PLK DESIGN 2 (6) replaces PLK DESIGN 1 (5) and most PLK DESIGN 1 (5) C-numbers
Where applicable, PLK DESIGN 1 (5) and C-numbers have been automatically converted

PLK DESIGN 2 (6)

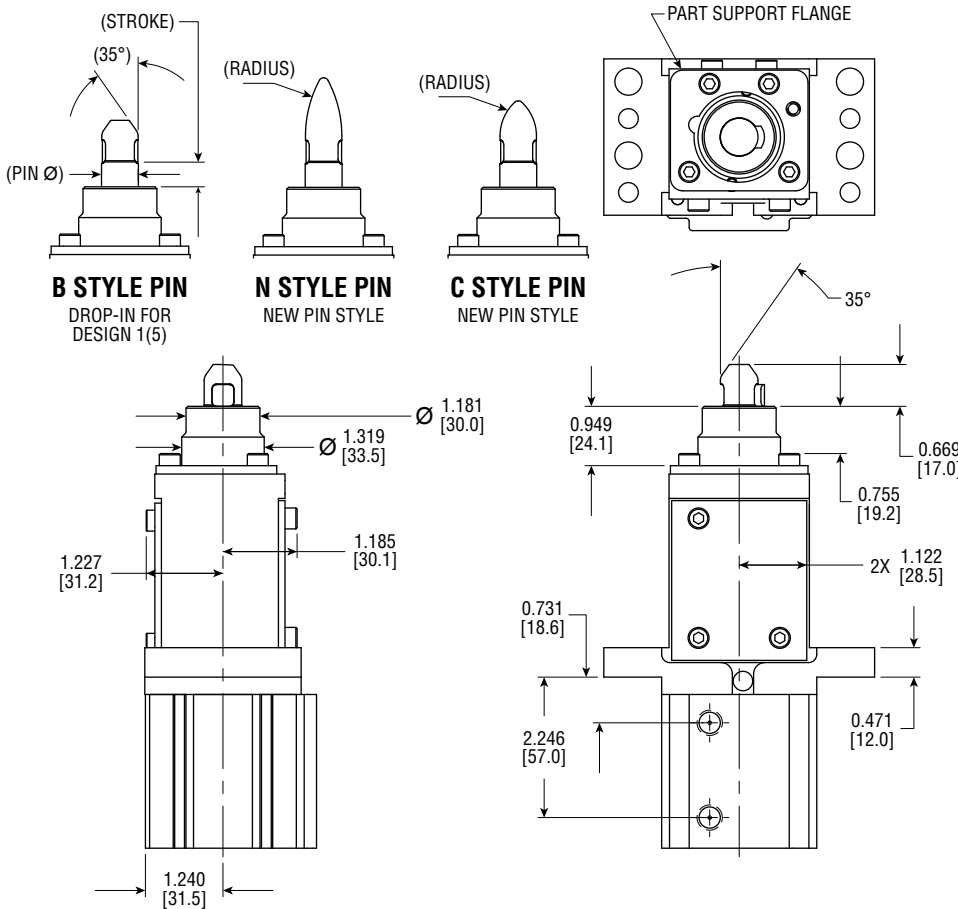
- 2 strokes (505 & 510)
- Imperial (2) & Metric (6) Ports
- 1800 pin diameters 12.00 thru 30.00 (+.00/- .02 mm Tolerance)
- 3 Pin Styles (B, C & N)
- Std. Flange Mount Height (110 mm to 140 mm - .5 mm increments)
- 4 Std. Finger Directions (Easily changed in the field)
- Standard Single Finger and Dual Finger (15 mm dia and above)
- Port Position 1 thru 4 (available with all positional sensing options)
- Port Fittings (-LAA & LBB)
- Cylinder Options (-R01 & R02)
- Cylinder Switch options (SW00, 41, 42, 51 & 52)
- Additional Rear Mounting options standard (-B01 thru -B06)
- Lock Setting (-MT00 thru -MT40) (See page 2 for new lock adjustment procedures)

PIN Ø = PIN Ø SPECIFIED = +0.00 / -0.02 mm
 (+0.0000 / -0.0008 in)

PIN Ø AVAILABLE FROM 12.00 mm TO 30.00 mm
